ADDENDUM NO. 5

TO: PLANS AND SPECIFICATIONS FOR STATE OF MISSOURI

Renovate Mechanical / Electrical / Life-Safety / State Office Building
Jefferson State Office Building
205 Jefferson Street
Jefferson City, MO 65101
PROJECT NO. O1911-01

SHEET TITLE:
**FIRST
FLOOR PLAN
-MECHANICAL**

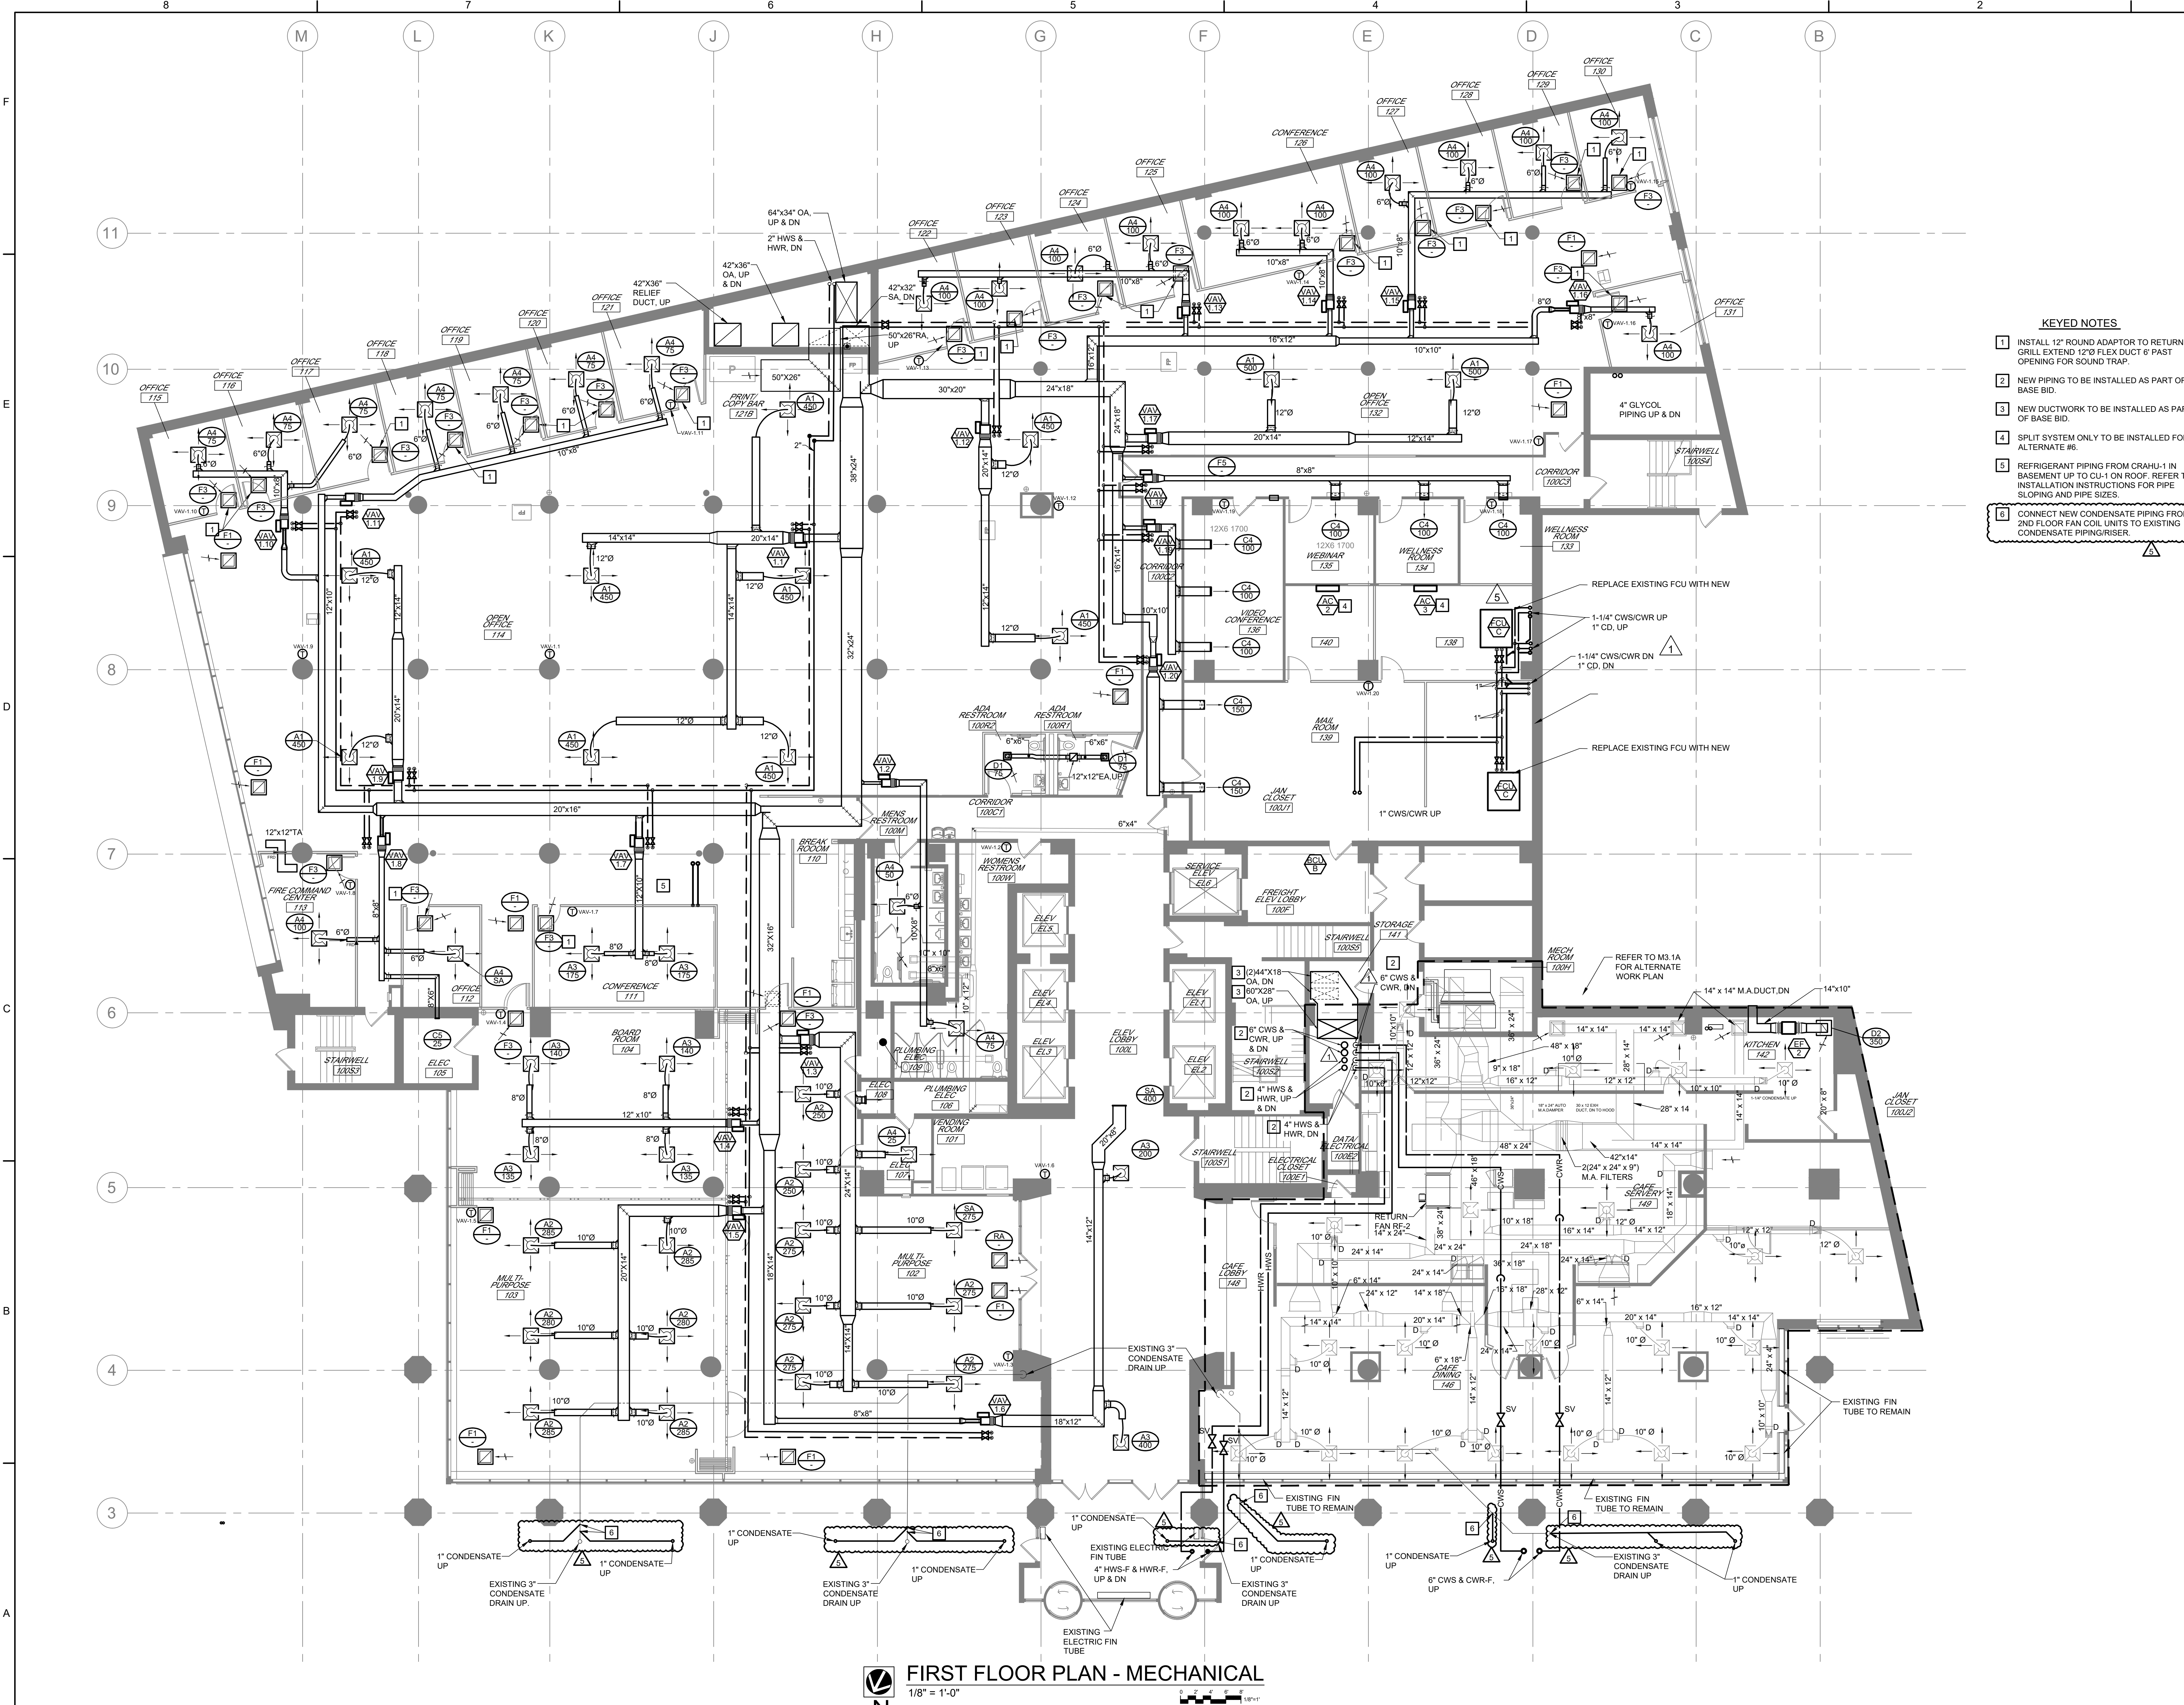
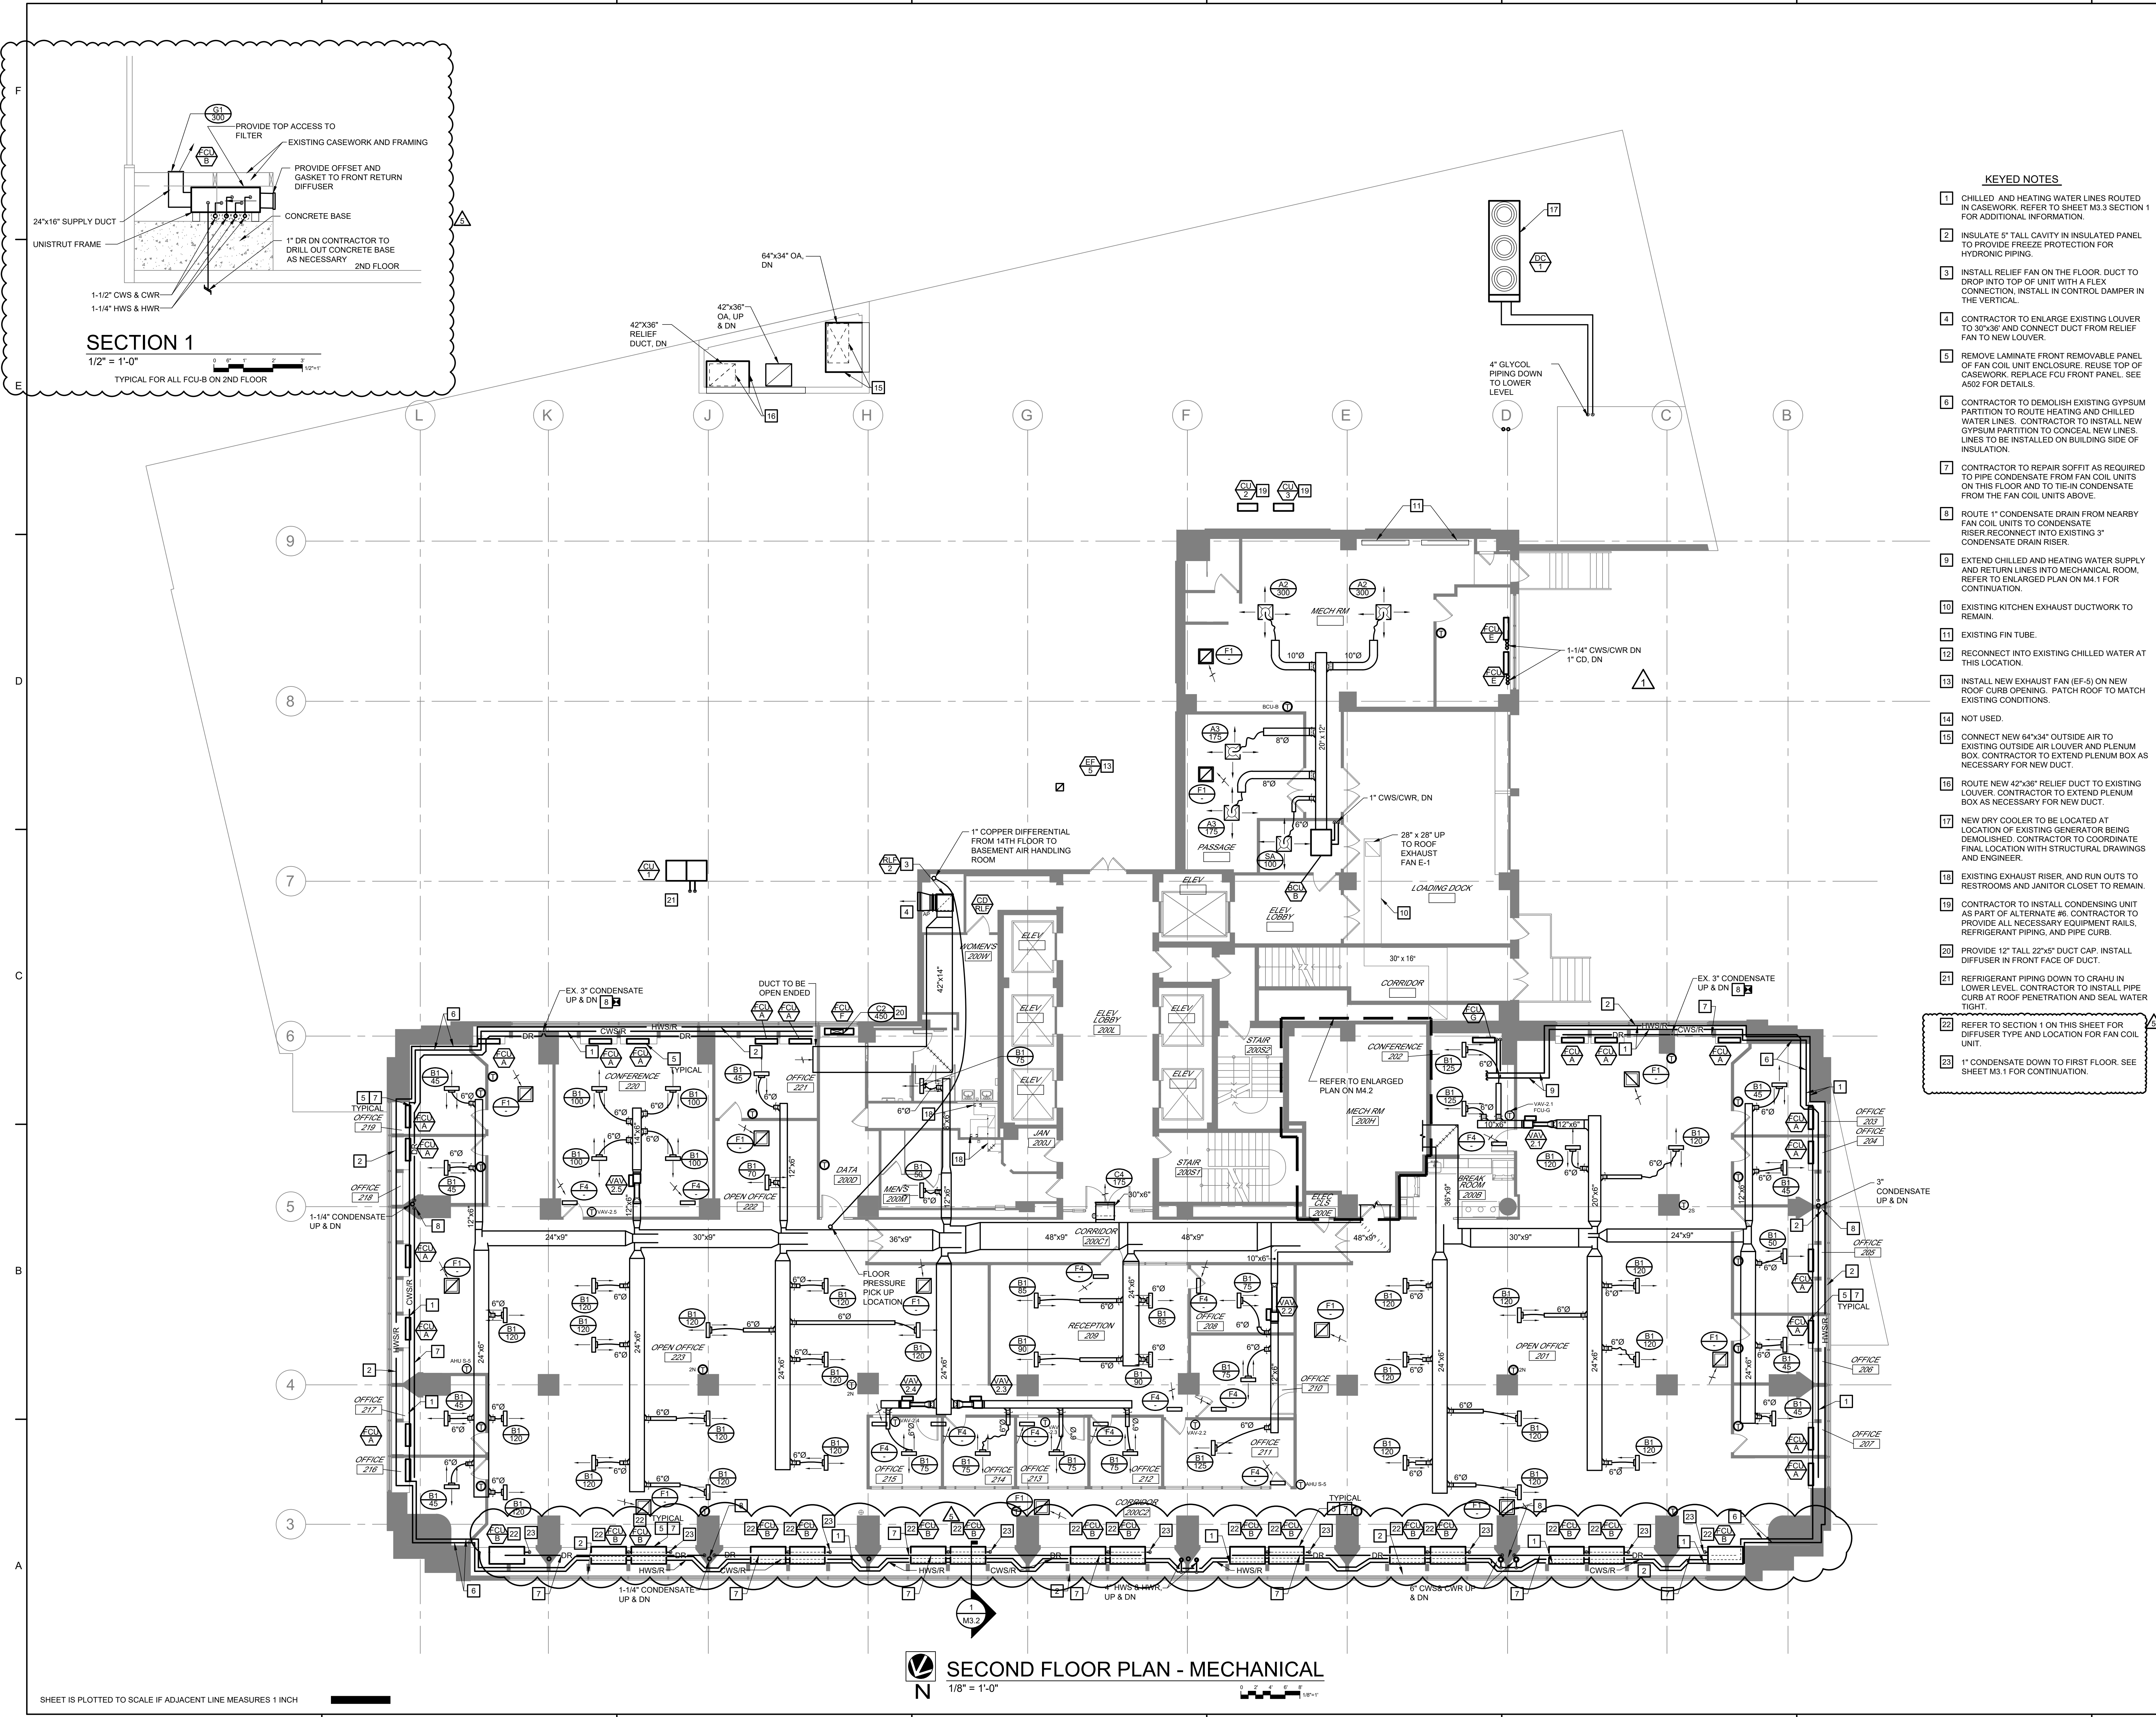
12. Drawing M3.1
- a. ADD - Condensate Piping.
13. Drawing M3.2
- a. ADD - FCU Section.
 - b. Adjust Piping.
14. Drawing M3.3
- a. ADD - FCU Section.
15. Drawing M3.12
